JTAG Port and issues with the Raven and/or Jeeni debug tools

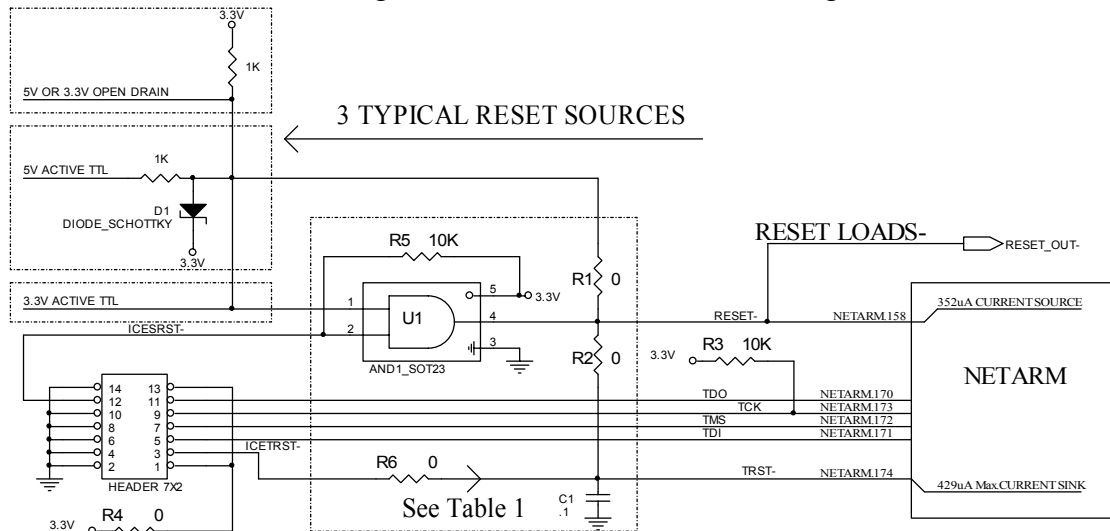
Some customers have run into problems gaining control of the NET+ARM processor after it has executed illegal instructions. This can happen if the flash ROM is corrupted, or is disconnected. Netsilicon has investigated this problem. Up to now we designed the JTAG interface on our development boards according to the *Basic nTRST Connection* described in ARM's Application Note 31, and have passed these recommendations onto our customers as well. This design ties NET+ARM TRST- and RESET- together. We have found that this design does not always allow a JTAG debugger ICE to gain control of the processor after it has executed illegal instructions. The nSRST and nTRST signals need to be kept separate. The nSRST signal should be connected to nRESET on the processor, and nTRST should be connected to nTRST on the processor. The schematic below shows the correct design. Customers should use this design in all new boards.

Leaving TRST* pulled to a logic "low" on production units is not recommended. The noise margin on inputs at a logic "0" are only a few tenths of a volt.

Customers who have boards that followed the old design guidelines should update them to follow the design above, if possible. If it is not possible to patch the existing boards, then the following procedure will usually gain control of the boards that use the old design, even if flash is corrupted.
